July 13, 2010

RE: CUYAHOGA COUNTY  
TINKERS CREEK BASIN  
CITY OF MAPLE HEIGHTS  
NEW STAFFORD MIDDLE SCHOOL

Figure 1. Water appears to have found its way underneath the inlet protection.

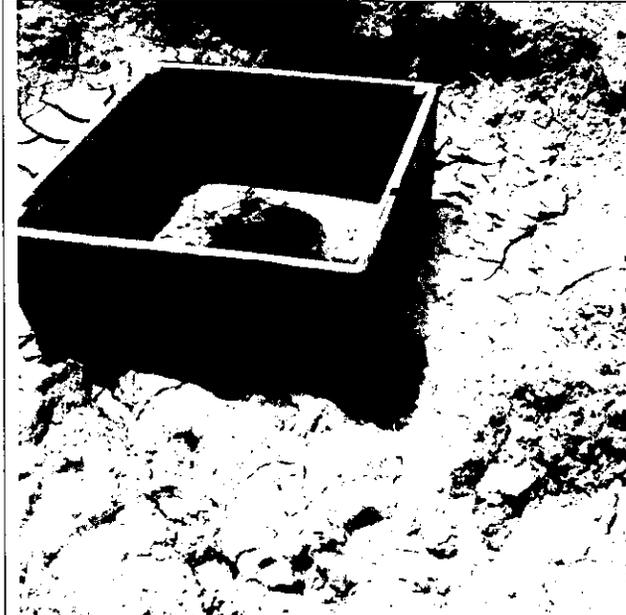
- Sediment basin #1 (SB1) was being installed at the time of inspection. Ensure the outlet structure and skimmer are installed in accordance with the site's storm water pollution prevention plan (SWP3).
- Inlet protection around inlet #2 (IP2) appears to have been breached (Figure 1). Ensure the inlet protection has been installed properly. Repair or reinstall inlet protection in accordance with the site's SWP3.
- The rock check dam in TD3 as it enters into sediment trap #2 (ST2) was observed to be in need of repair (Figure 2). Repair or reinstall the rock check dam in accordance with the site's SWP3.
- There were issues with the installation of the silt fence along the east end of the site. Observations showed the backfill material to be unsuitable, wet or dry. Mr. Jensen stated that he would discuss the issue with Christopher Hartman of Chagrin Valley Engineering.
